MASSACHUSETTS DEPARTMENT OF TRANSPORTATION HIGHWAY DIVISION

SPRINGFIELD MCKNIGHT COMMUNITY TRAIL			
STATE	FED. AID PROJ. NO.	SHEET NO.	TOTAL SHEETS
MA	-	1	66
PROJECT FILE NO.		608157

PLAN AND PROFILE OF MCKNIGHT COMMUNITY TRAIL

25% SUBMITTAL

SIGN & PAVEMENT MARKING PLANS

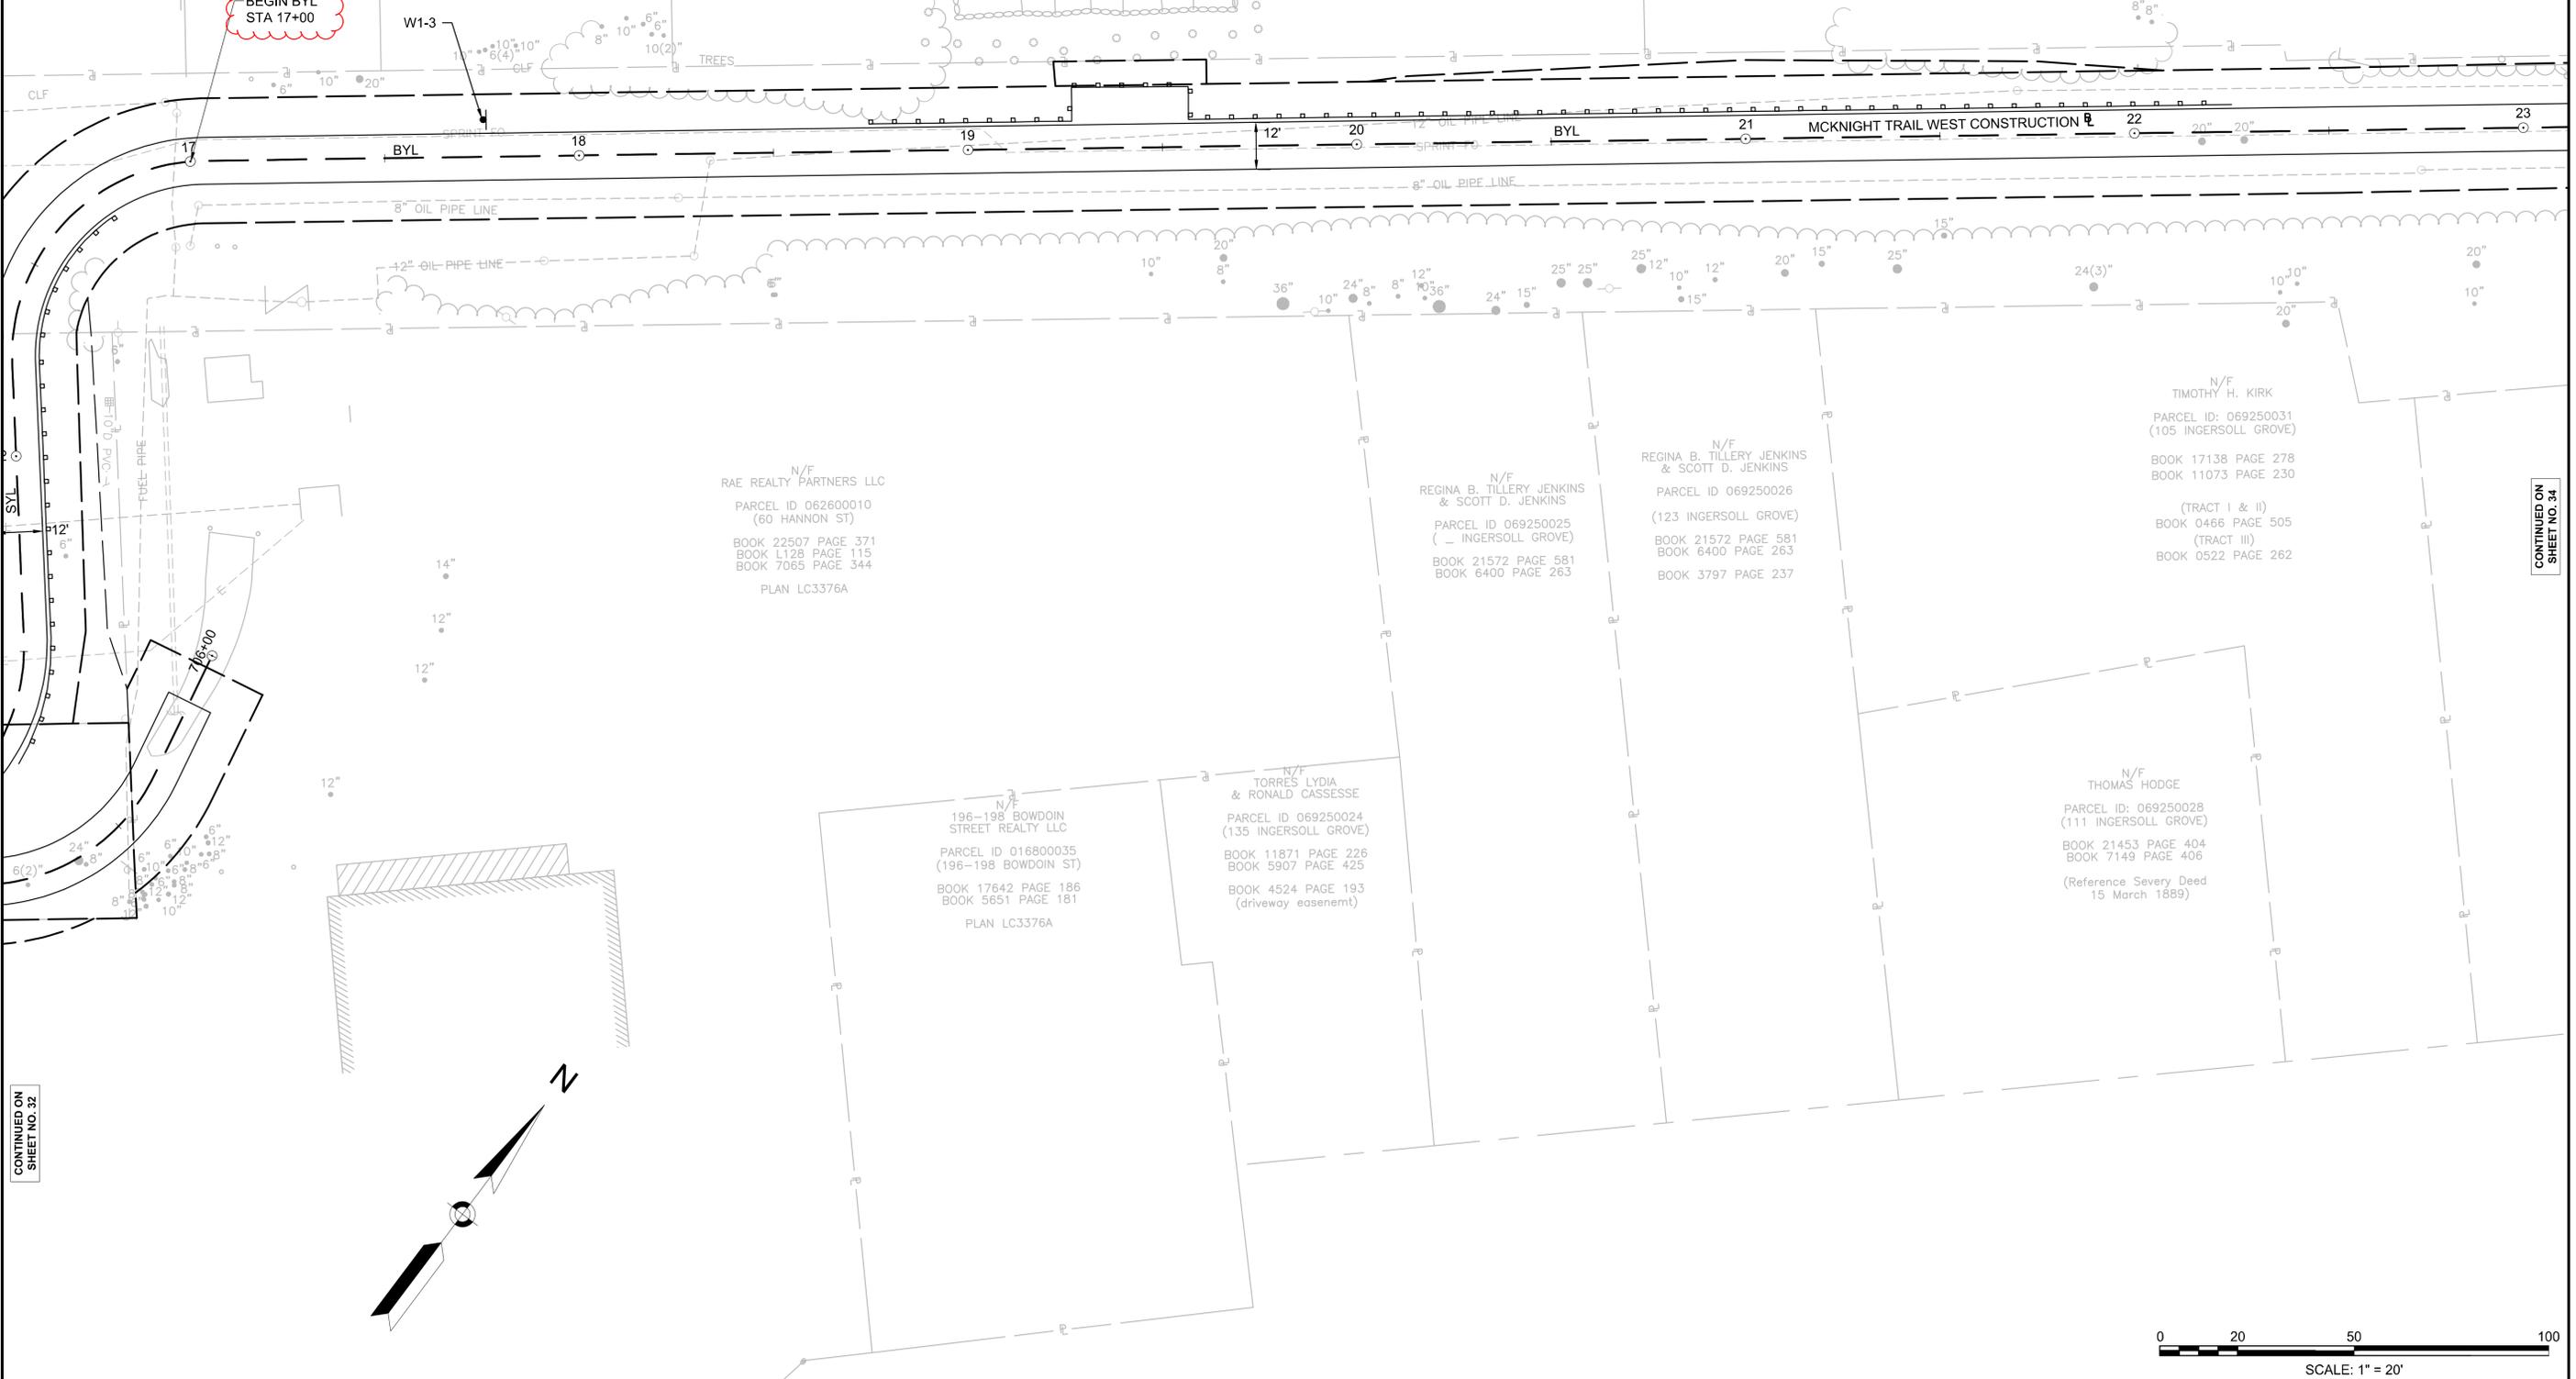
Show markings as actual
dashed and solid lines on
the plans, and not just as
notations. - SCT

SIGN & PAVEMENT MARKING PLANS

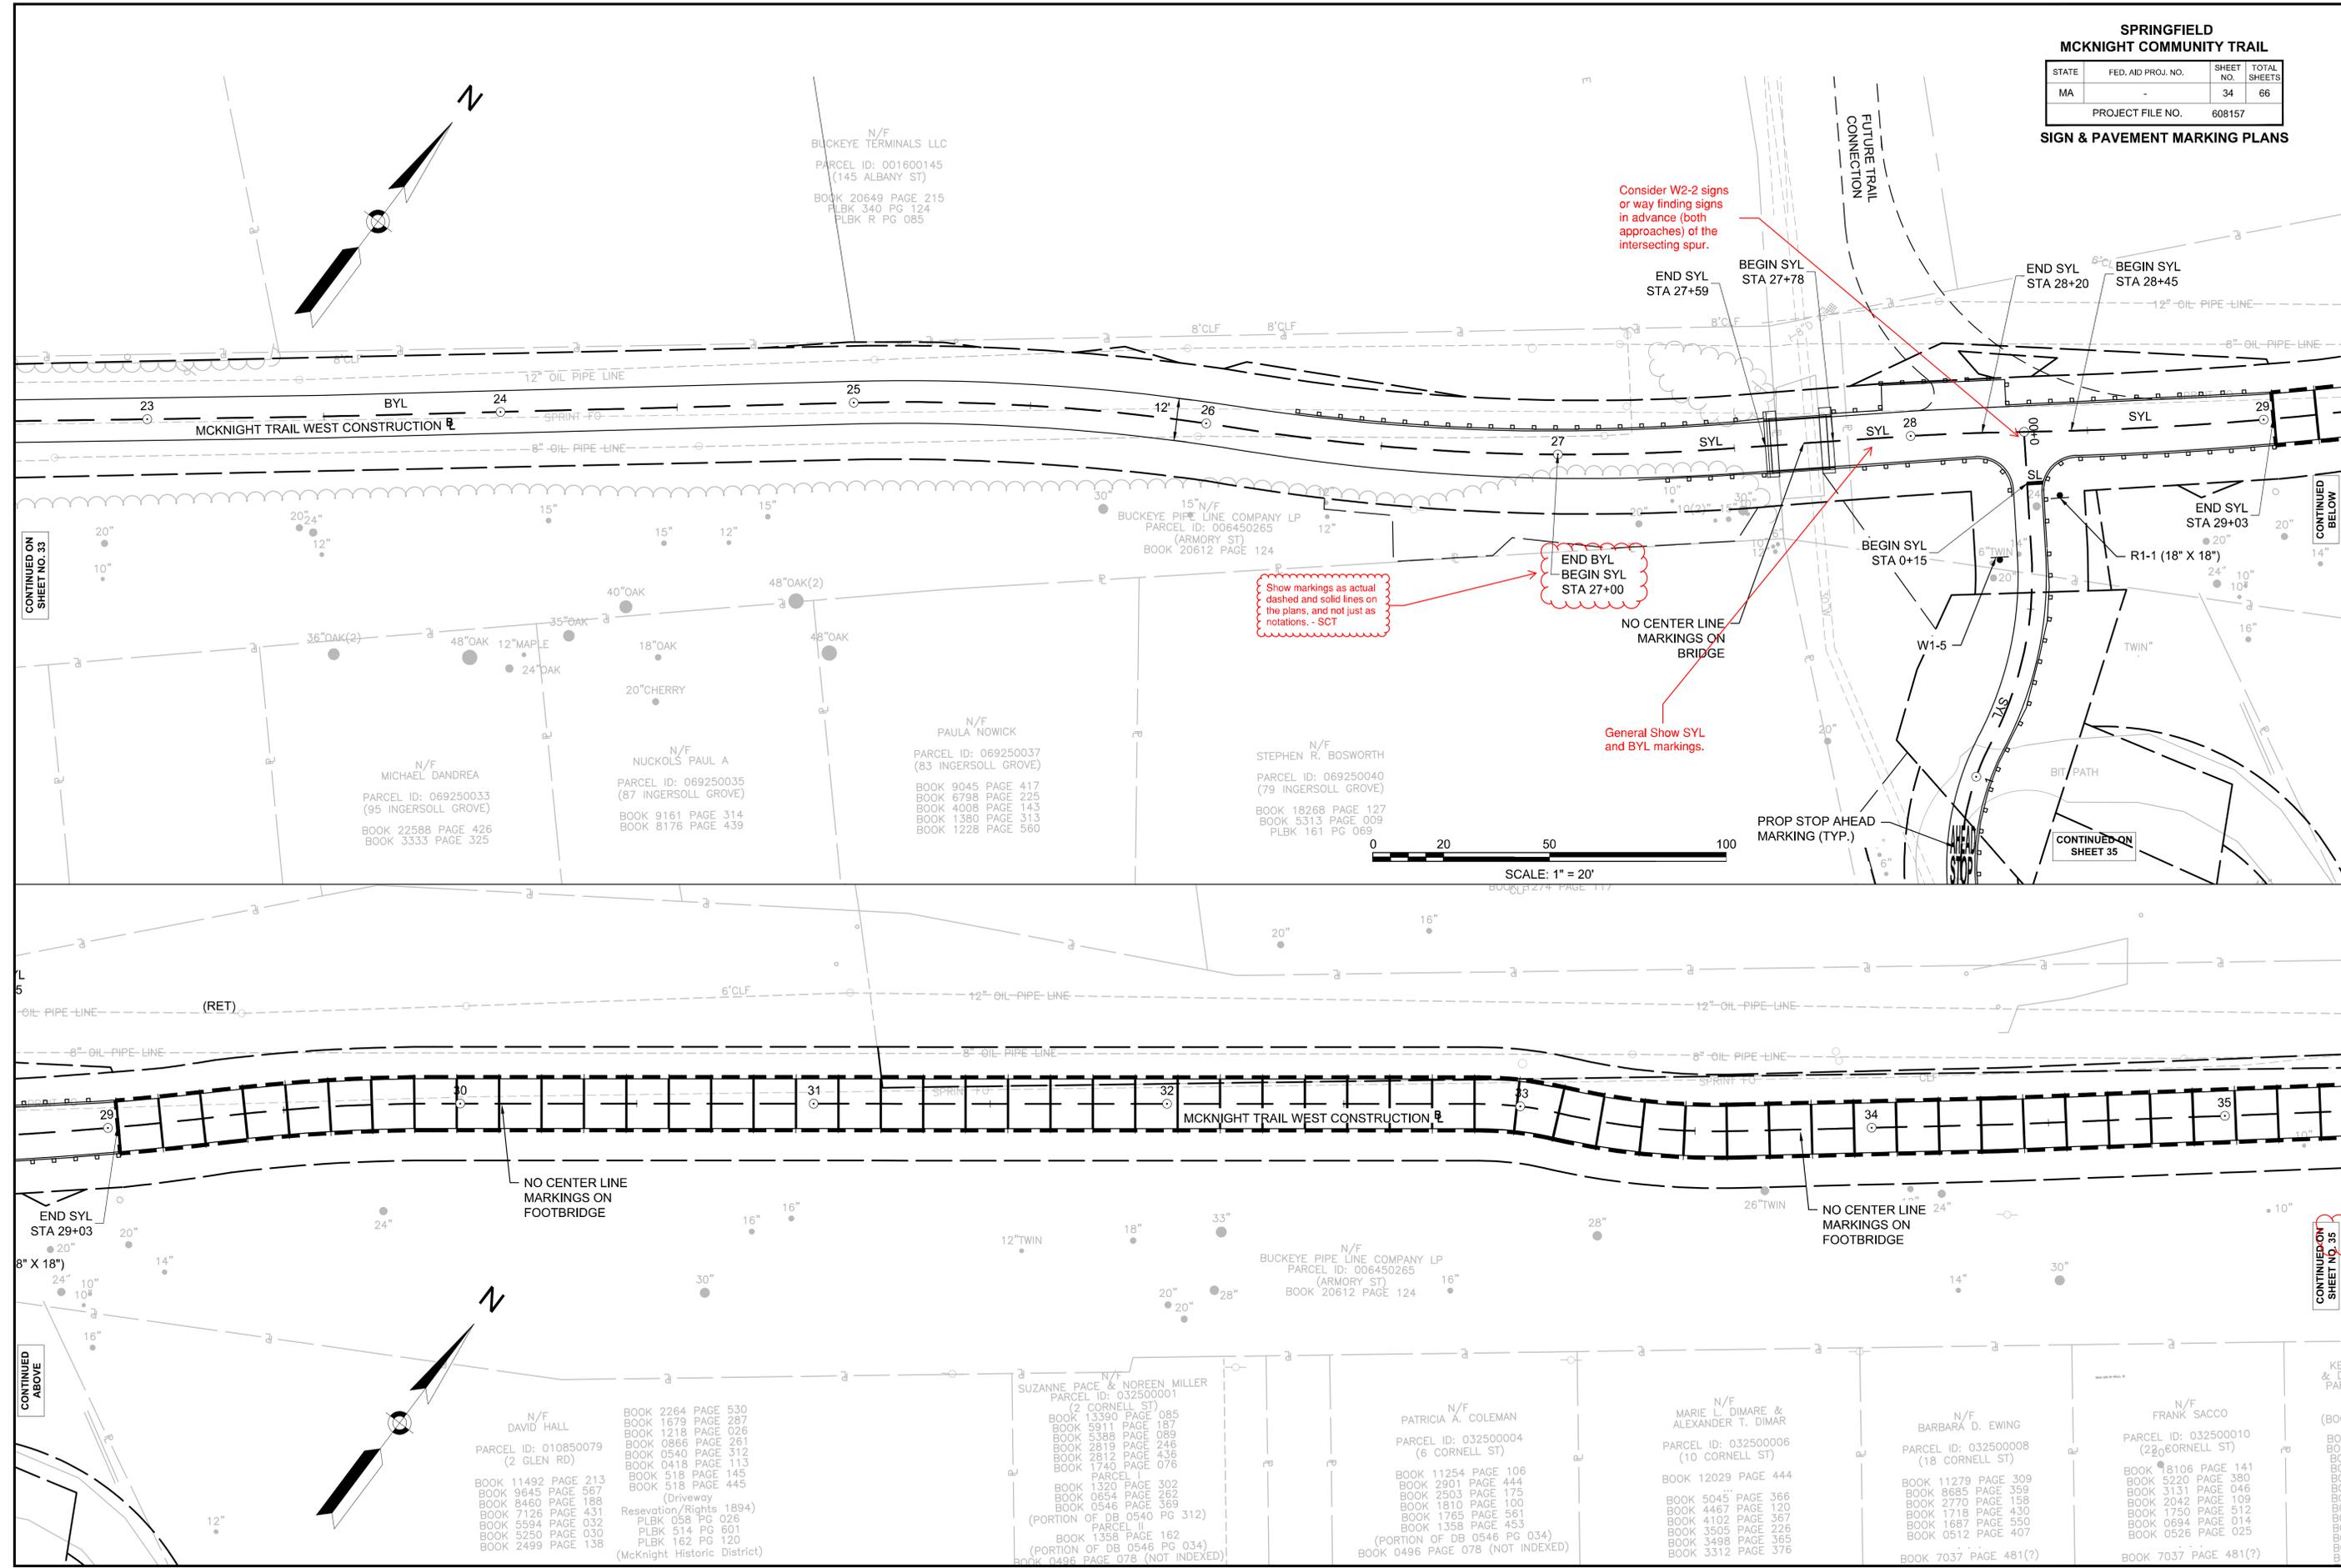
Show markings as actual
dashed and solid lines on
the plans, and not just as
notations. - SCT

General Show SYL
and BYL markings.

SIGN & PAVEMENT MARKING PLANS

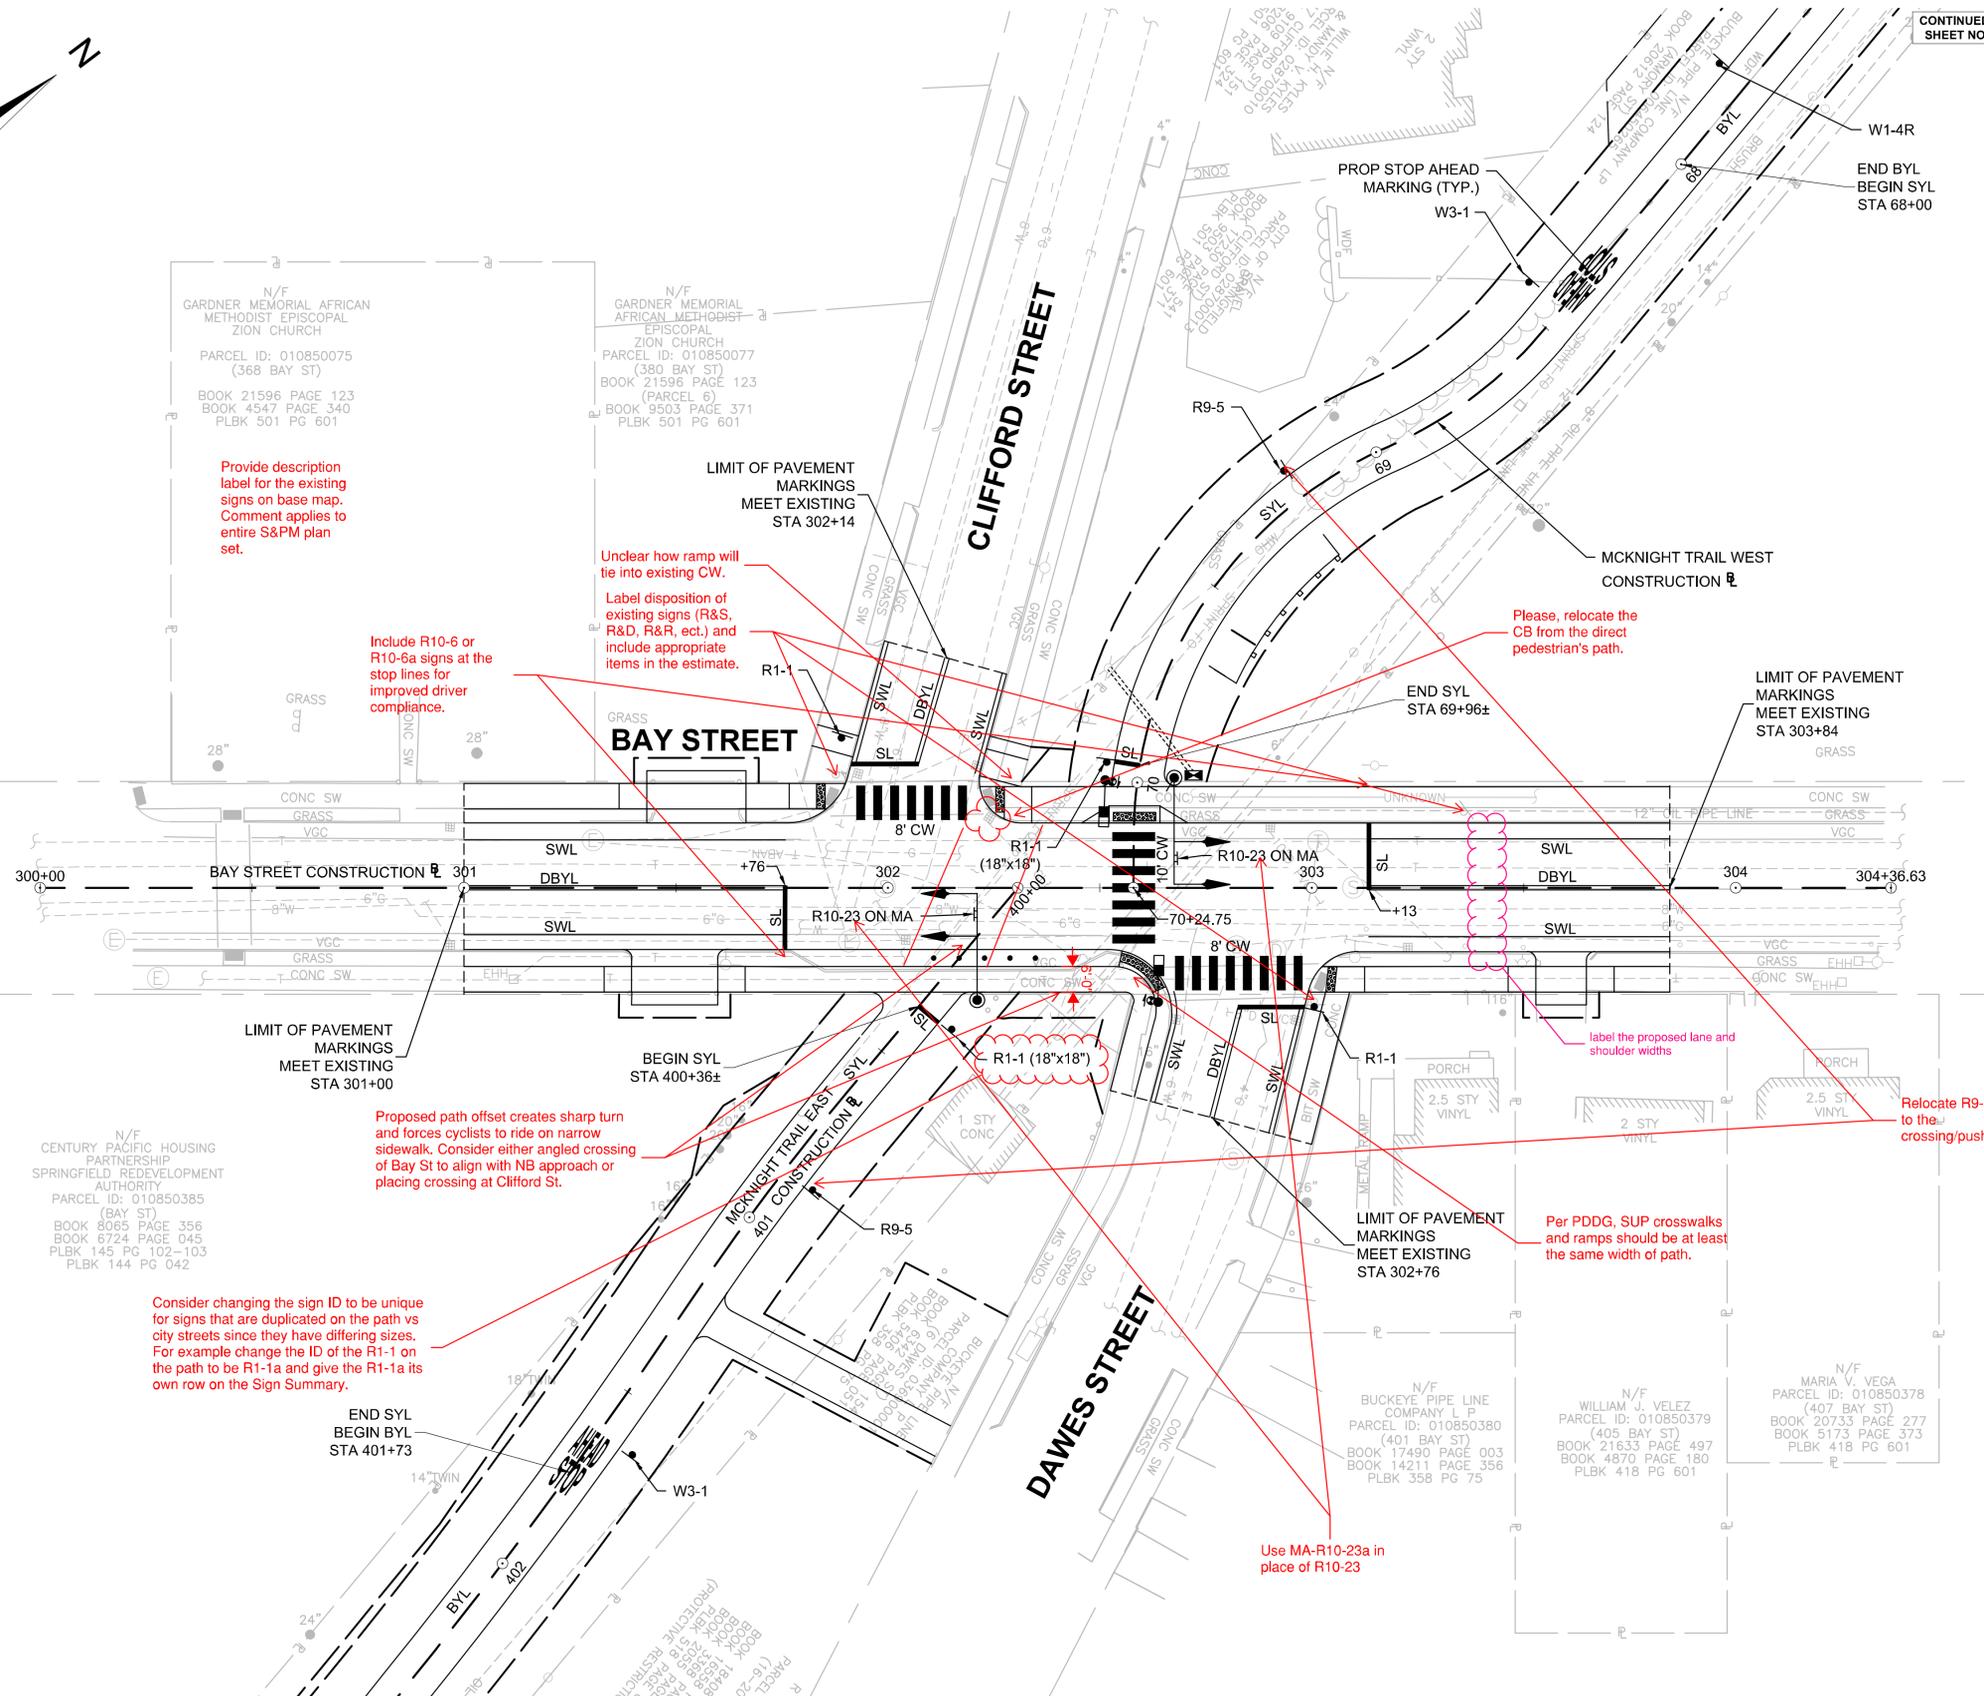
Provide description label for the existing signs on base map. Comment applies to entire S&PM plan set.

Consider changing the sign ID to be unique for signs that are duplicated on the path vs city streets since they have differing sizes. For example change the ID of the R1-1 on the path to be R1-1a and give the R1-1a its own row on the Sign Summary.
